RESPONSE TO REQUEST FOR ADDITIONAL INFORMATION

US-APWR Design Certification

RAI NO.: NO. 812-5983 REVISION 3
SRP SECTION: 03.07.02 – Seismic System Analysis
APPLICATION SECTION: 3.7.2
DATE OF RAI ISSUE: 08/23/2011

QUESTION NO. 03.07.02-109:

Figure 1 ATF at Center, Basemat Bottom (El. -39.667 ft), N-S Direction, 270-200 Soil

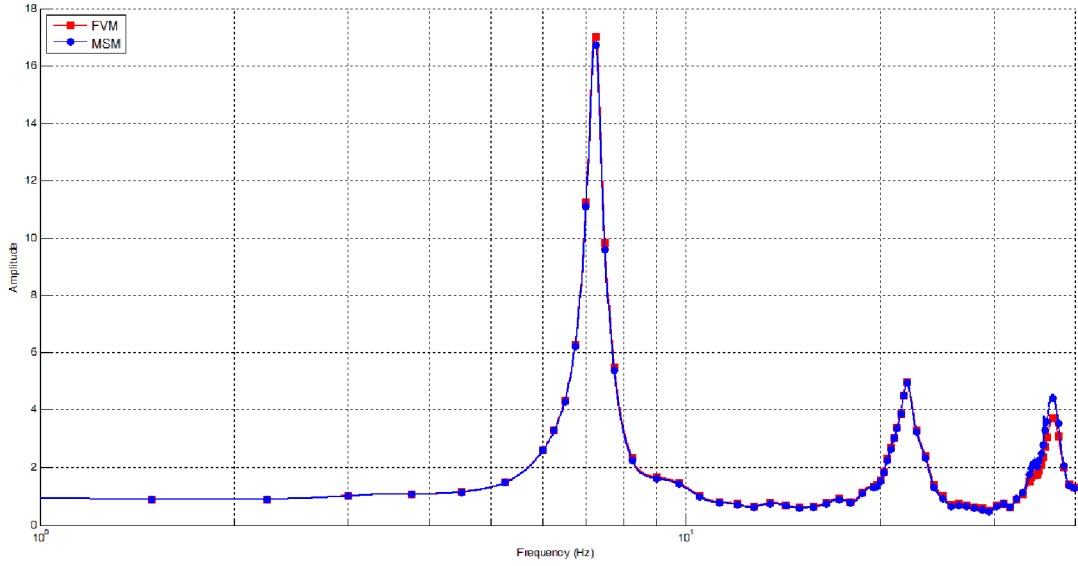
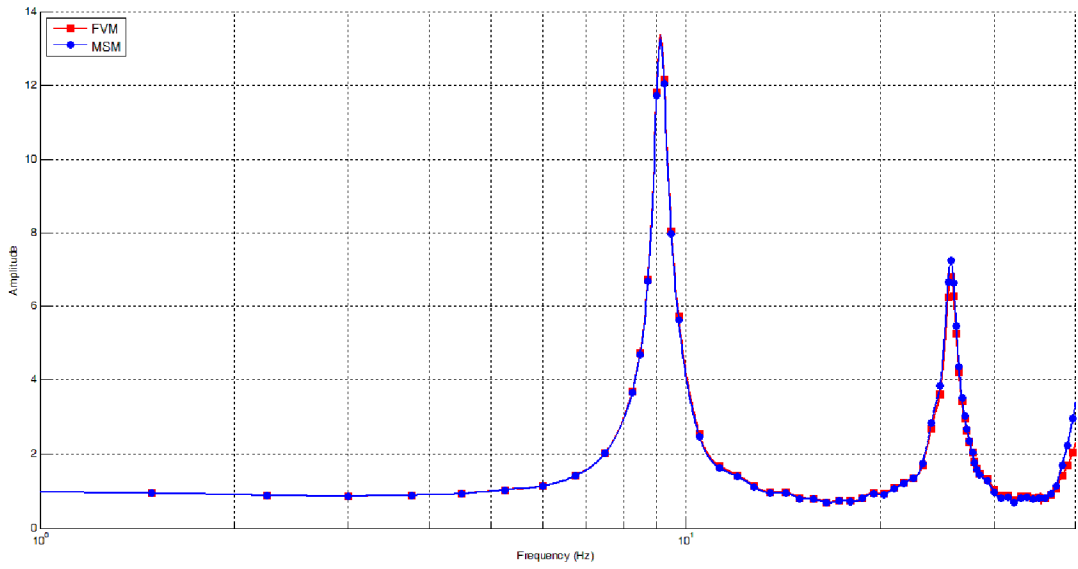
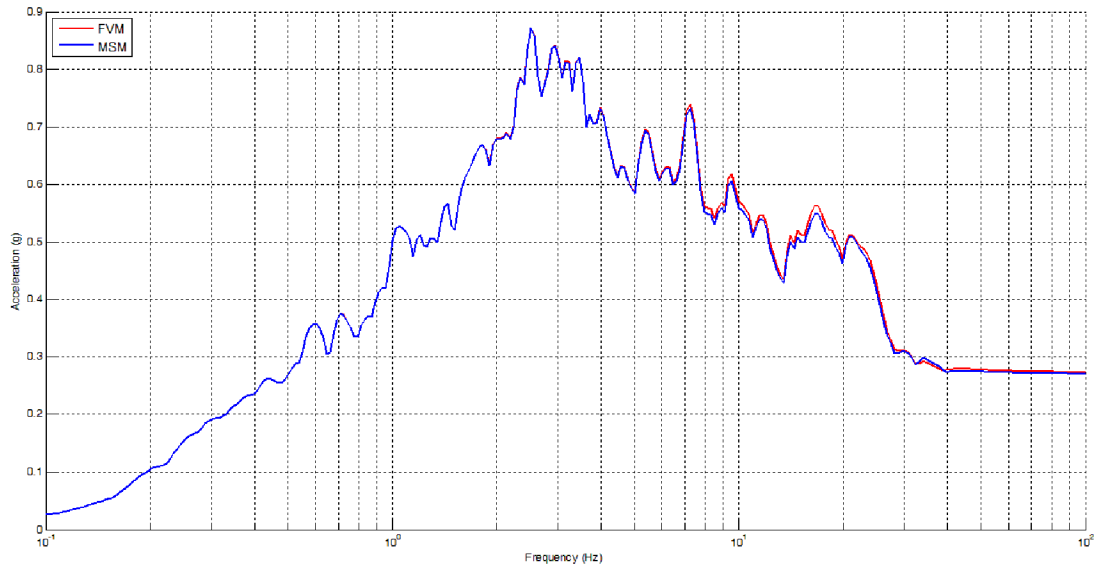
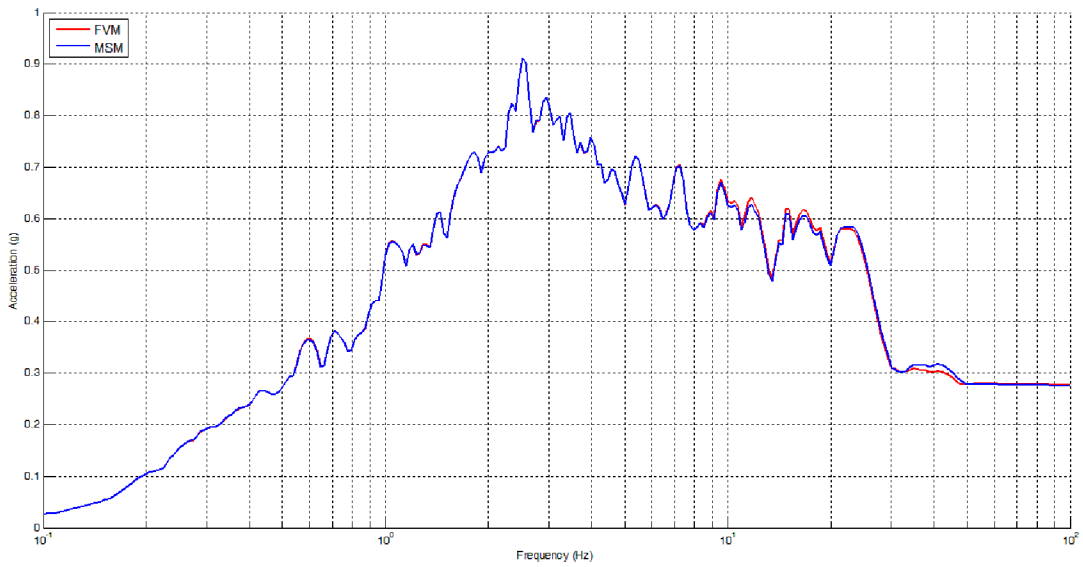
In section 3.7.2.1 of the DCD (R3), the Applicant stated that the seismic response of standard plant seismic category I and II structures is obtained from site-independent analyses performed using three-dimensional SSI models with the program ACS SASSI. The applicant is requested to clarify whether the flexible volume method or subtraction method is used in performing the SSI analysis with ACS SASSI computer program and provide the technical basis and justification for the method used in the SSI analysis.

Figure 1 to Figure 4 present typical ATF and ARS comparison plots at a typical location, center of basemat bottom, from Study 1 for fully bonded embedment condition. Figure 5 to Figure 6 present the typical results of Study 2 at the reactor support. Review of the ATF and ARS comparison plots indicated that the acceptance criteria are met for both Study 1 and Study 2. The 5% damping ARS computed using MSM at reviewed locations match closely to the 5% damping ARS using FVM. At a few frequencies for some locations, downward deviation of MSM is observed from Study 1 results but well below 15%.
